DUNLOP TIRE CORPORATION  
TONAWANDA, NEW YORK

## **CLOSURE OF INACTIVE WASTE SITE NO's 915018 A, B & C**

- **QUALITY ASSURANCE/QUALITY CONTROL PLAN**
  - **PROJECT CONTINGENCY PLAN**
  - **OPERATION & MAINTENACE PLAN**
  - **LONG TERM MONITORING PLAN**
-

**FOR THE CLOSURE OF  
INACTIVE WASTE SITE NO's 915018 A, B & C**

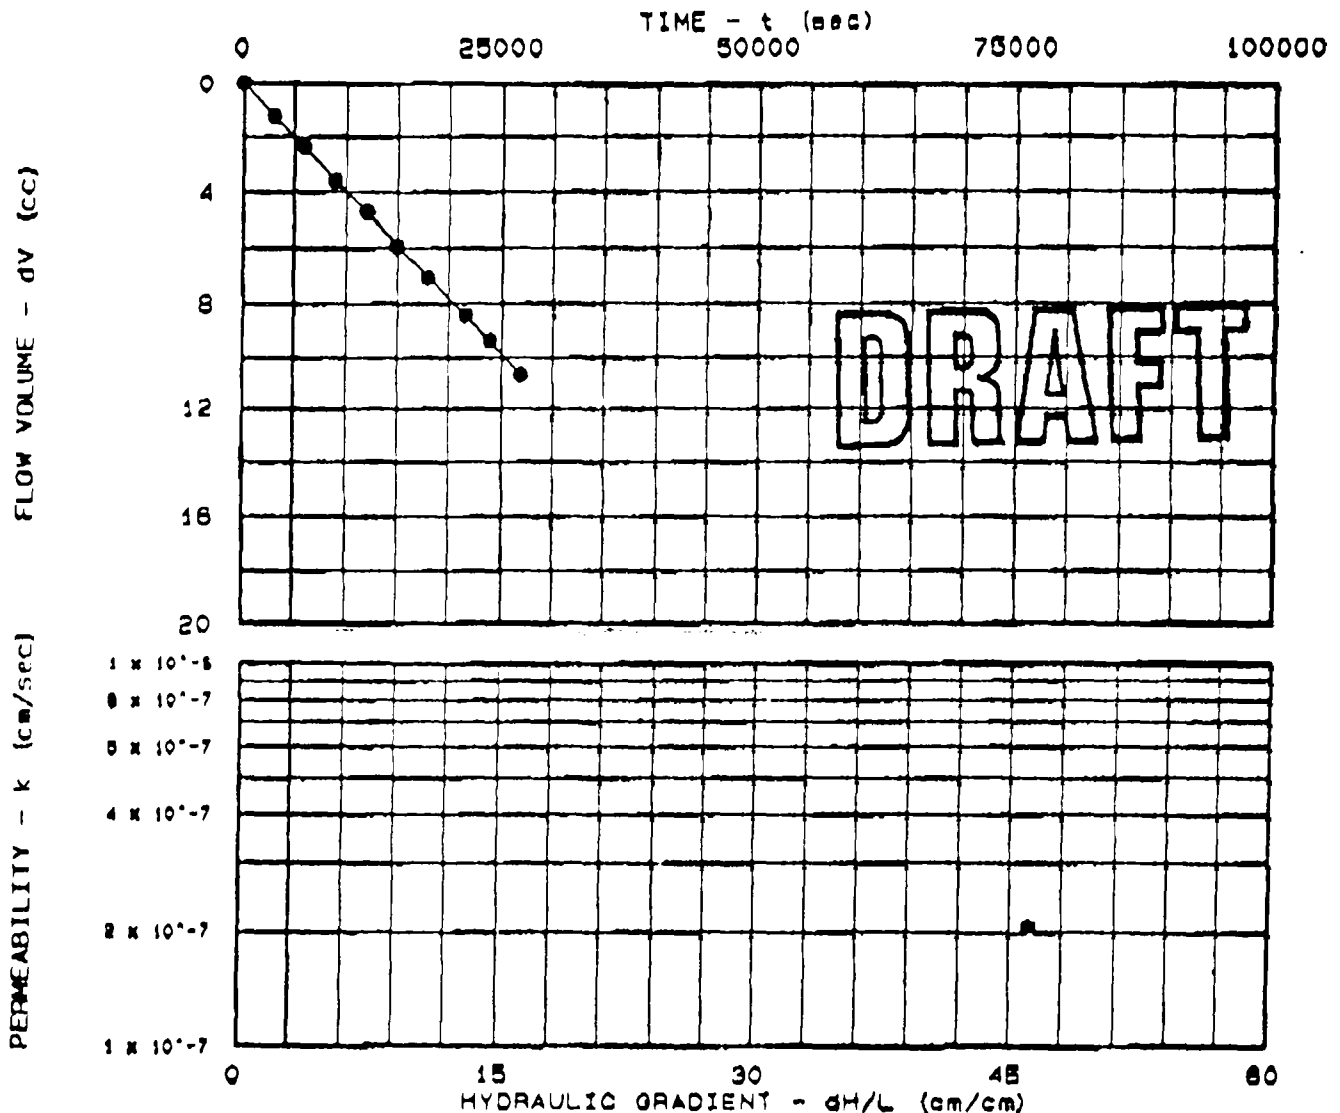
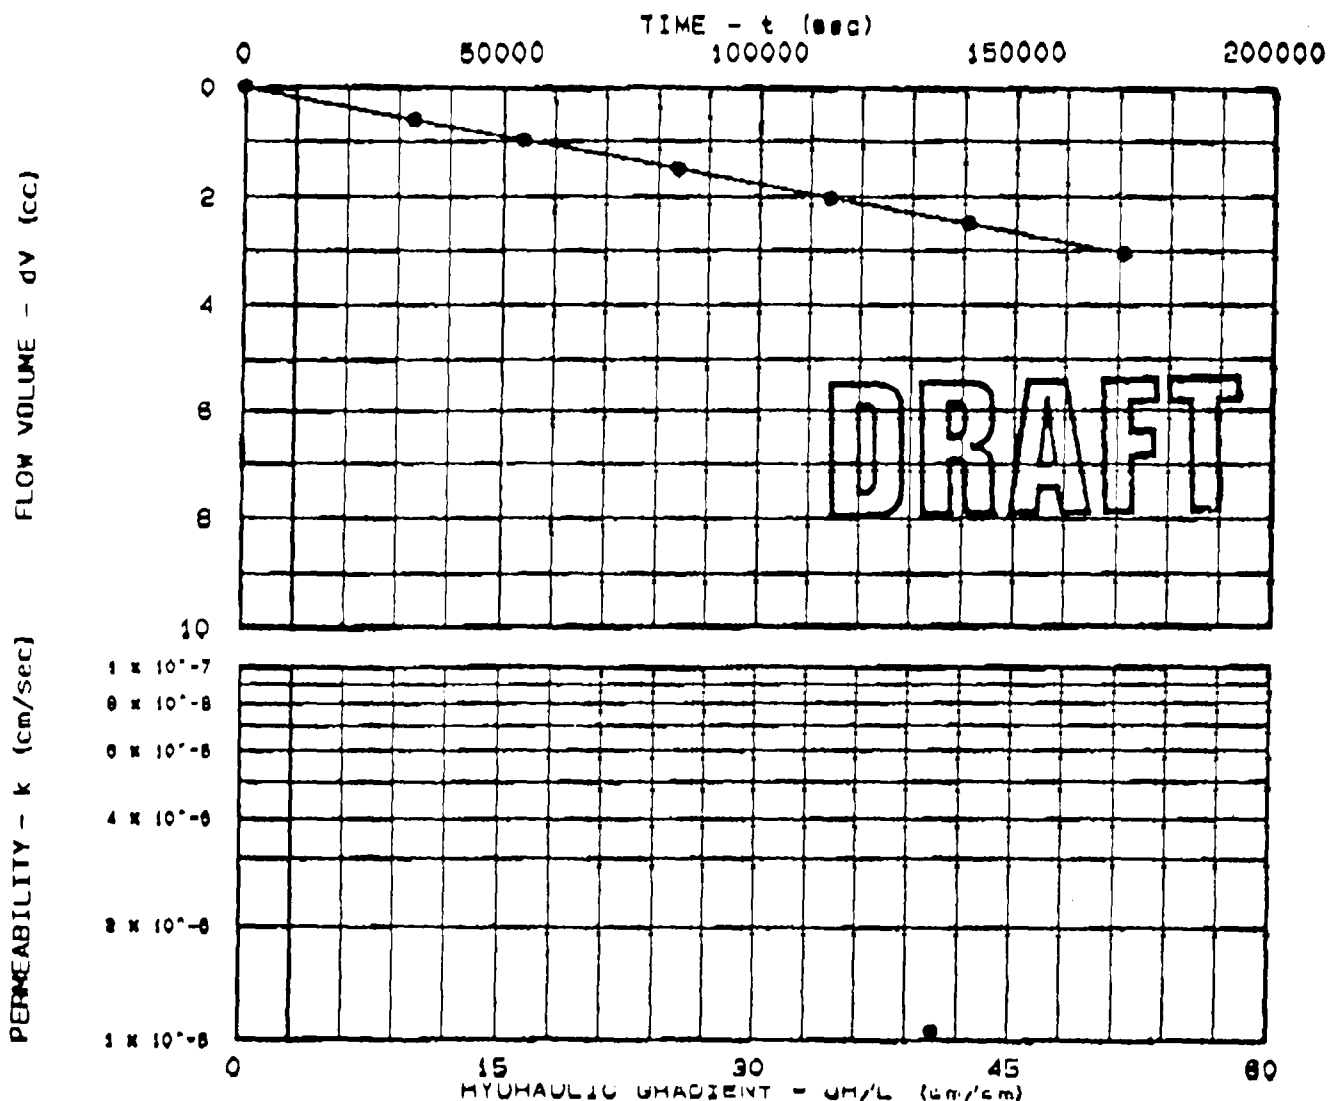
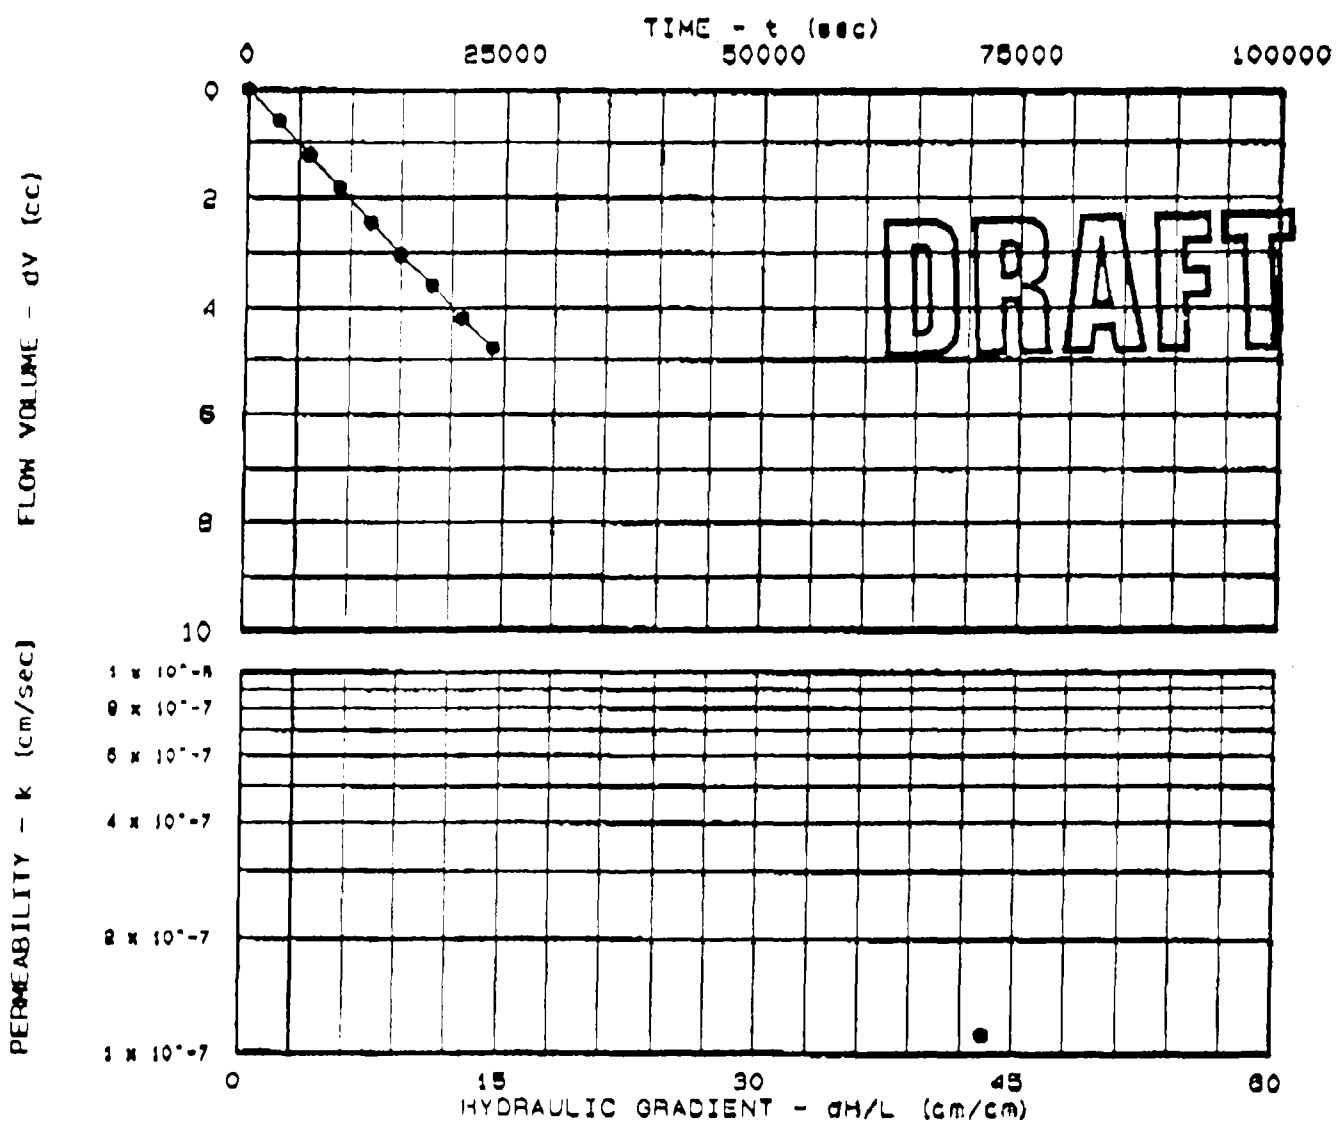
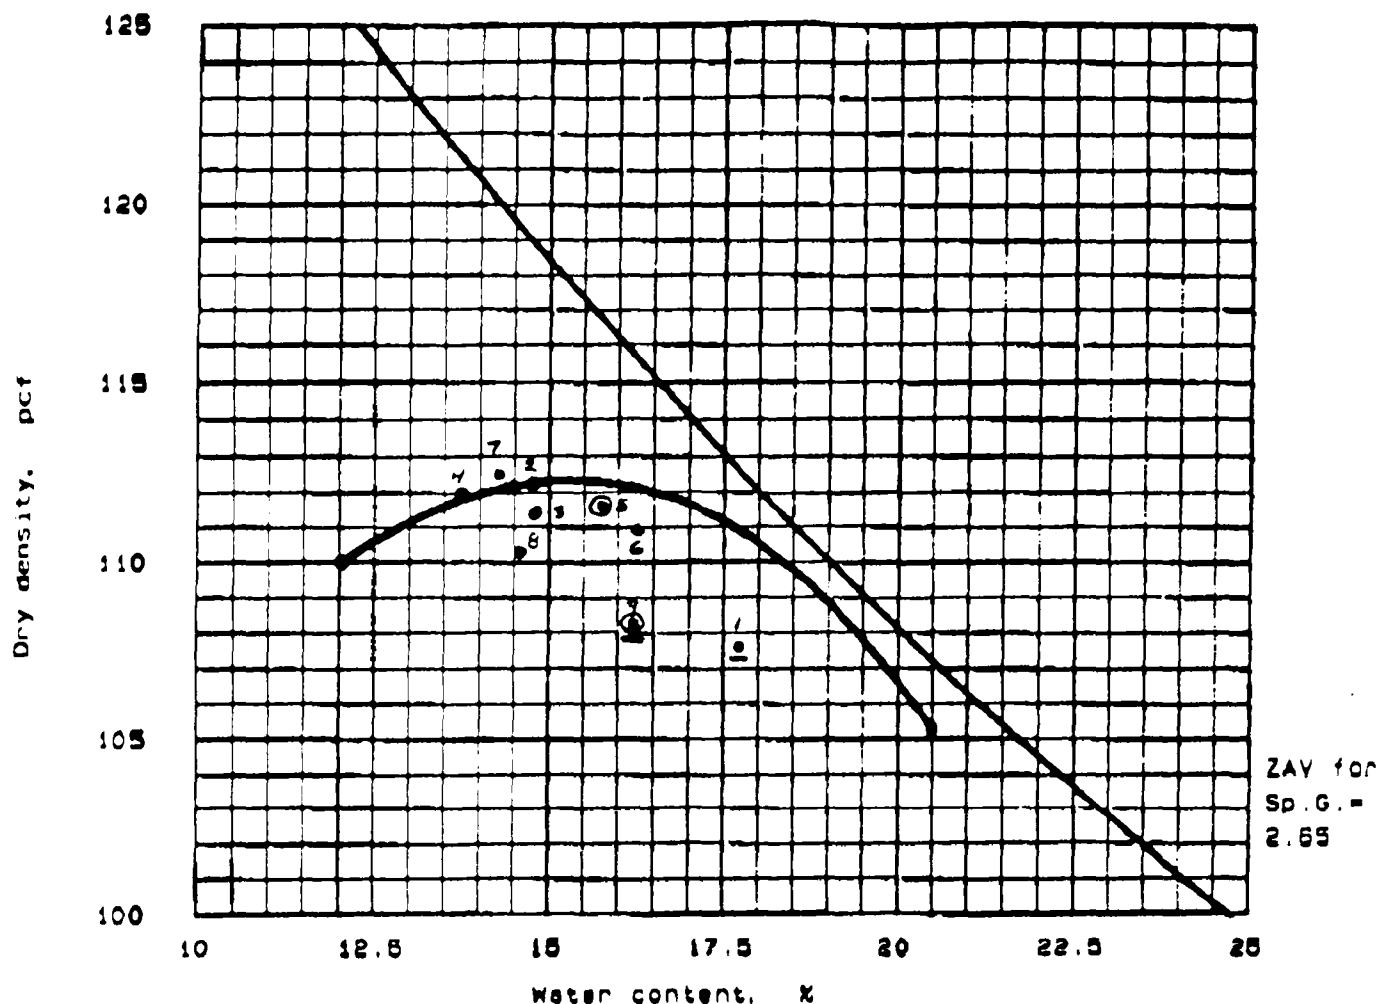
The clay test pad at southern Area B was constructed on July 16, 1993. Four in-place density (IPD) tests were conducted, while two Shelby tube samples were obtained for lab permeability testing. Information concerning these tests are attached.

Results of the permeability tests indicate that one sample passed and one sample failed the permeability requirements. Because the Shelby tubes were not pushed in areas where IPD's were measured, it was difficult to evaluate the correlation between field measurements and lab permeabilities. The lab, however, indicated that the failed sample appeared to be less compacted and moist than the passing sample. Because the Shelby tubes were pushed with a backhoe bucket, where side-to-side movement can occur during sample collection, and knowing that the tube ends were not sealed with wax, it was suspected that the sample was adversely affected during transport to the lab.

This Shelby tube sample again failed the permeability requirement, with a permeability of  $1.17 \times 10^{-7}$  cm/sec. A review of the grain size data (attached) indicates, however, that the upper three feet of material in the borrow pit is high in silt, with clay contents only ranging from 27.1 to 31.8%. This factor probably explains both the permeability failures and the less compacted and moist character of the Shelby tube samples.

I discussed this issue with Mr. Alan Zylinski who has been extensively involved in capping and testing operations. Department regulations do not specify a minimum clay content for landfill caps, however, experience indicates that minimum clay contents of

35-40% are typically required to obtain the permeabilities desired. The less compacted and moist character of the failed samples can be attributed to the high silt/low clay content of the cap material. As permeabilities of this soil are in the  $10^{-8}$  cm/sec range, indicating that the required permeabilities can be obtained, Mr. Zylinski suggested that in lieu of rejecting the soil, compacting this material 3-4% wet of optimum should produce the required permeabilities. The passing Shelby tube sample, in fact, did have a higher moisture content than the two failing samples.

Discussions with URS, Dunlop and Dames & Moore were conducted on July 22 and 23, 1993 to resolve this issue. One aspect of this problem concerns the definition of the "average permeability" as stated in the approved conceptual plan. URS believes the "average permeability" to be that permeability obtained from the center of the Shelby tube sample. I stated that the Department's initial concern with the proposal to place a single 18 inch lift of clay was the ability to properly compact the entire thickness. The IPD measurements are only representative of the upper 12 inches of the cap, as this is the maximum depth obtainable by the equipment. The permeability tests, however, are only representative of the lower 6 inches of cap, as this is the portion of the sample tested. Either test, therefore, is not able to completely evaluate the entire thickness of the cap. Both tests combined, however, do evaluate the entire thickness, which provides a higher level of confidence that a single 18 inch lift can be adequately compacted.

A timely resolution of this issue is required as the project is already weeks behind schedule. As the permeability failures were marginal, and it is strongly believed that the desired permeabilities can be achieved by compacting the material 3-4% wet of optimum, the following compaction and testing protocols will be followed:

- 1) Compact clay from the affected zones, i.e. all of zone 1 and a part of zone 2, at 3-4% wet of optimum.
- 2) Conduct 9 IPD measurements per acre as required in the QA/QC plan and collect one Shelby tube sample per acre of the entire cap thickness. The sample location will be selected by Dames & Moore with the concurrence of URS and the NYSDEC field representatives.

- 3) The lab permeability test will be conducted on the bottom 6 inches of the Shelby tube sample. In the event of sample failure, and providing that the failure is marginal, a retest will be conducted on the midpoint of the original sample. This result will be considered the "average permeability" of that section of the cap. This definition for "average permeability" was subsequently found in the QA/QC plan approved by the Department. If the retested sample fails the permeability requirement, the area of soil represented by the failed sample will be scarified, moisture adjusted, recompacted, and retested as specified in the QA/QC plan.
